**Technical Service
BULLETIN**

SEAT CUSHION HEIGHT ADJUSTMENT HANDLE IMPROVEMENT

'03 – '04 4Runner

BODY
BO013-04

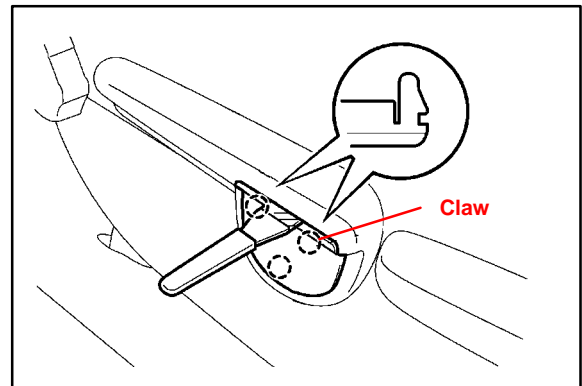
Introduction Some 2003 and 2004 model year 4Runner vehicles may experience a condition where the seat cushion height adjustment handle is contacted while entering or exiting the vehicle causing the seat adjustment to change. A new seat cushion height adjustment handle has been developed to correct this condition.

1. Remove the seat cushion height adjustment handle No.2.
 - A. Using a screwdriver, disengage the 3 claws and remove the seat cushion height adjustment handle LH.

- B. Remove the 2 screws and the seat cushion height adjustment handle.
2. Replace the seat cushion height adjustment handle with a new service part.
3. Installation is the reverse order of removal.
